CITY OF ALBUQUERQUE

RE: 1416 Espejo St NE
Grading and Drainage Plan
Engineer's Stamp Date: 03/09/2026
Hydrology File: J20D043
Case # HYDR-2026-00089

DRAINAGE AND TRANSPORTATION INFORMATION SHEET (REV 6/2018)

Grading Plan

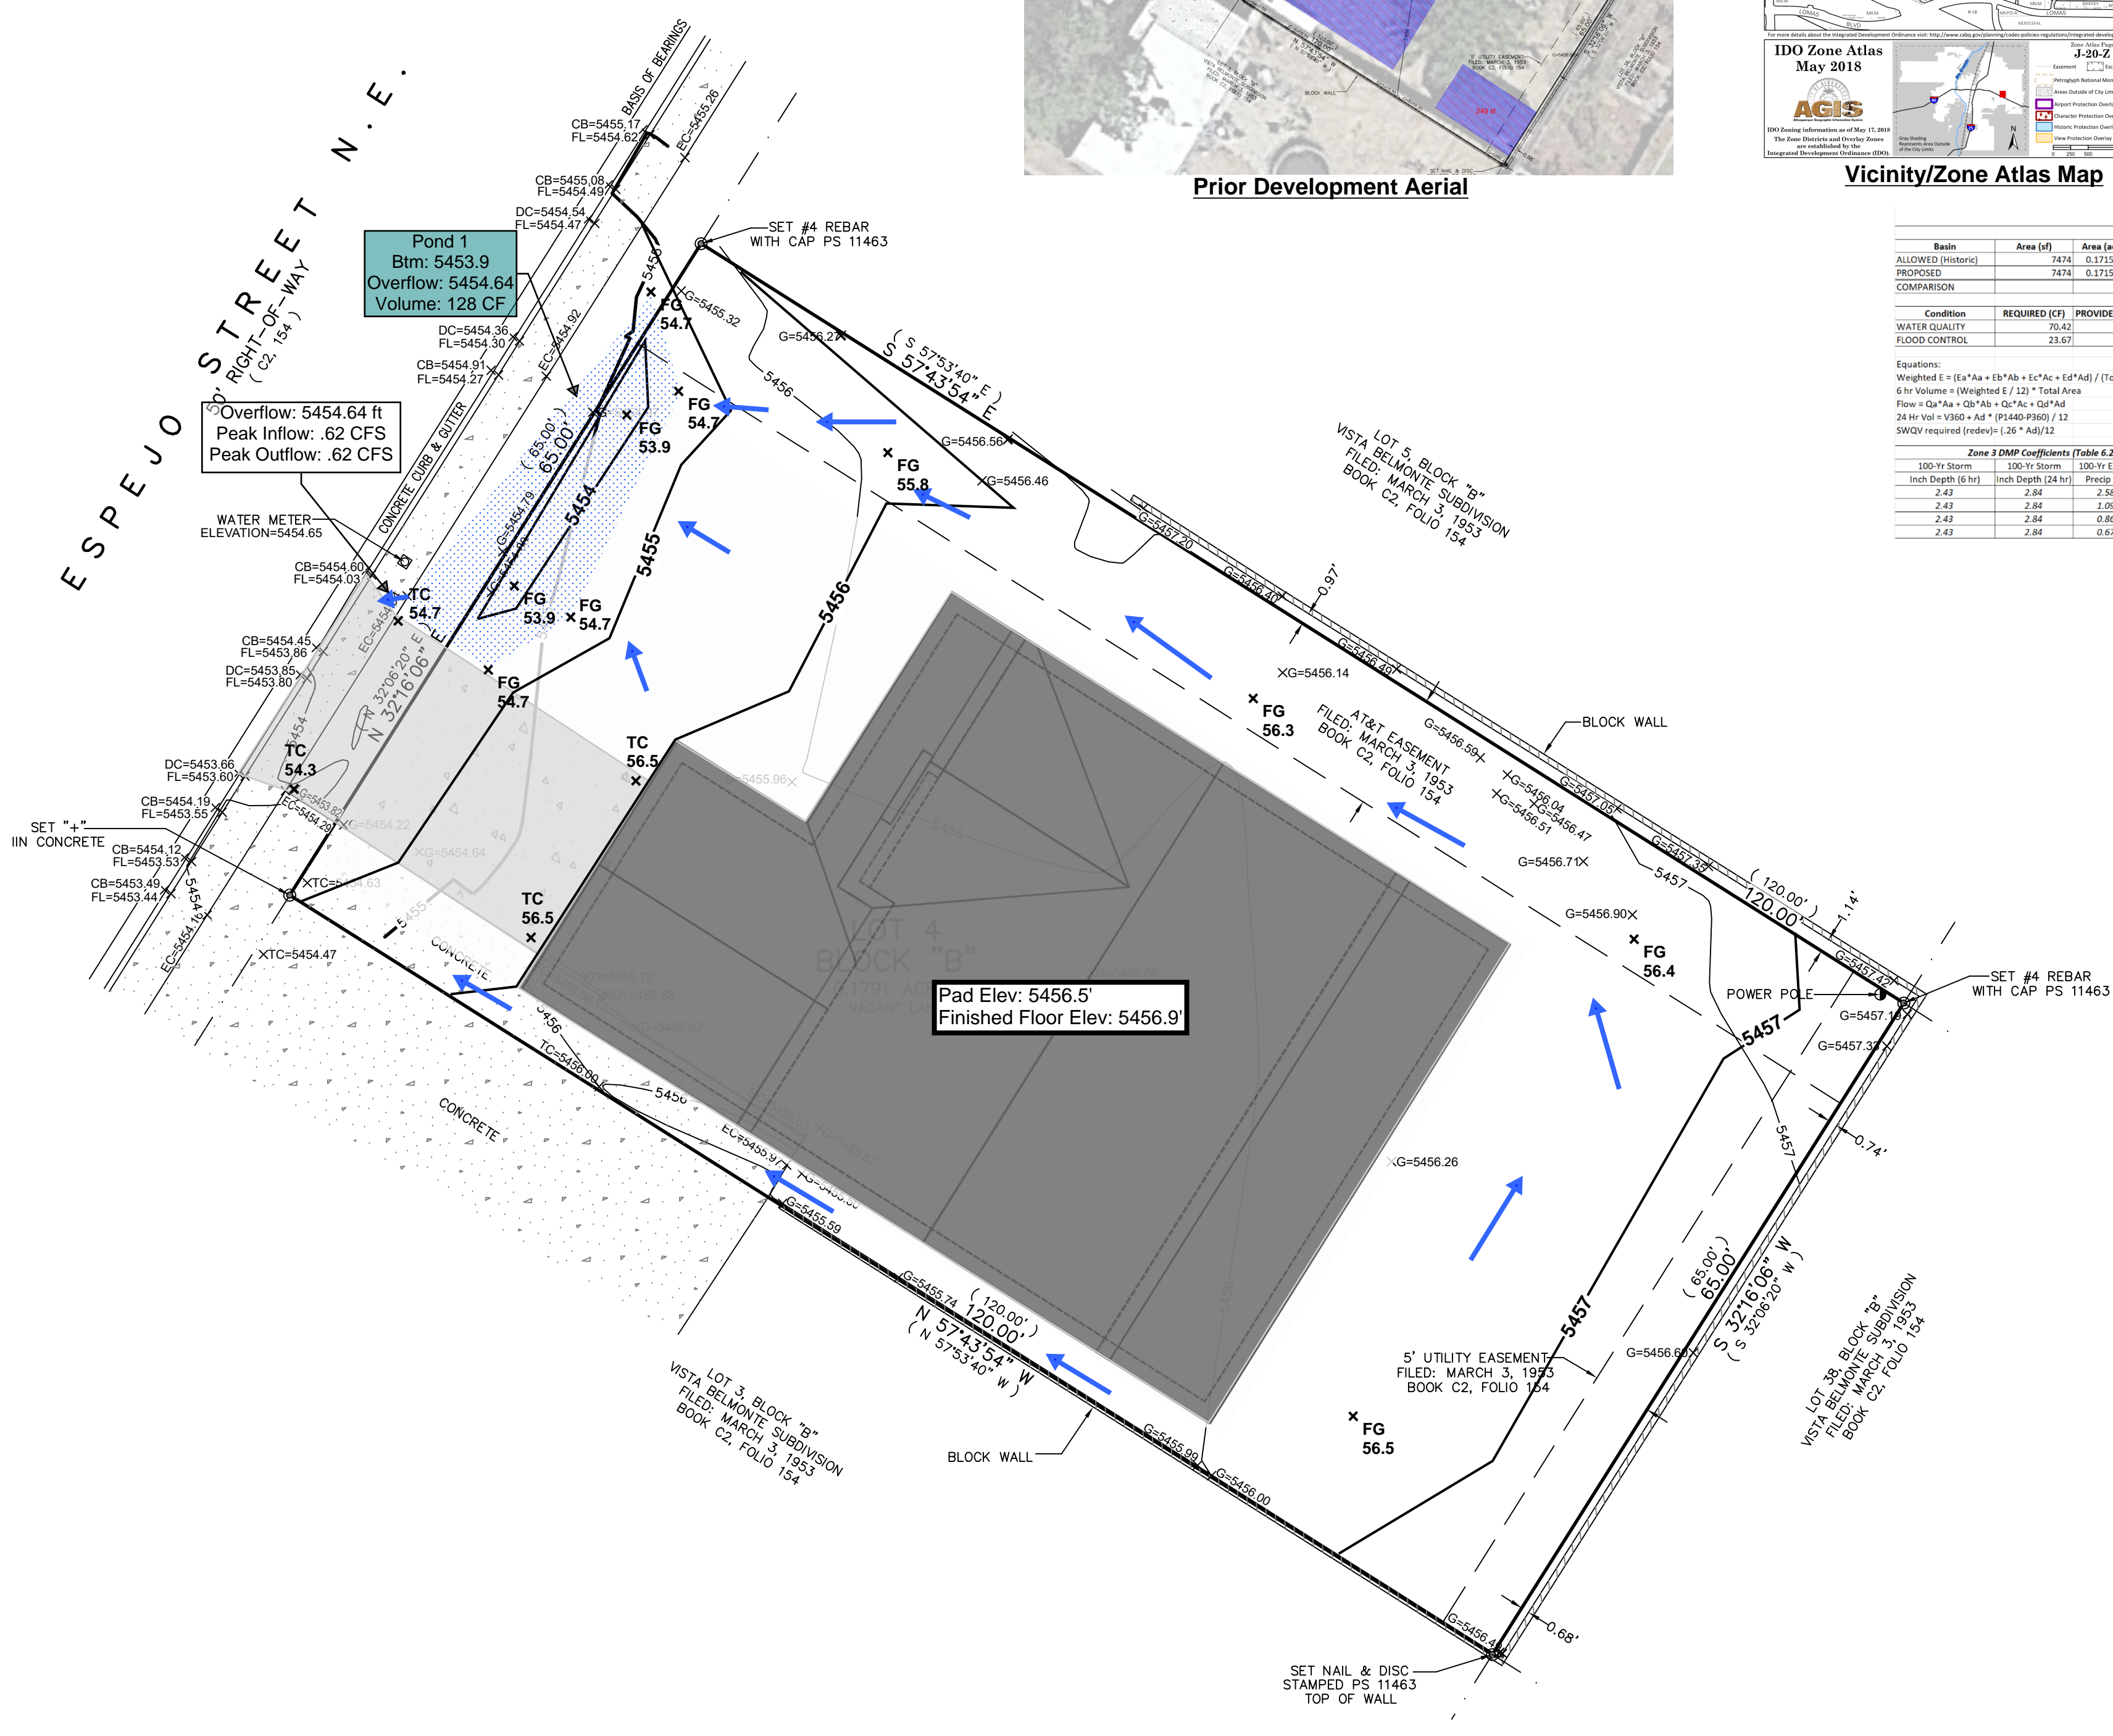
Based upon the information provided in your submittal received 03/13/2026, the Grading and Drainage Plan is approved for Grading Permit and Building Permit. Please attach a copy of this approved plan in the construction sets for Building Permit processing along with a copy of this letter.

1. Engineer's Certification, per the DPM Part 6-14 (F): Engineer's Certification Checklist for Non-Subdivision is required.
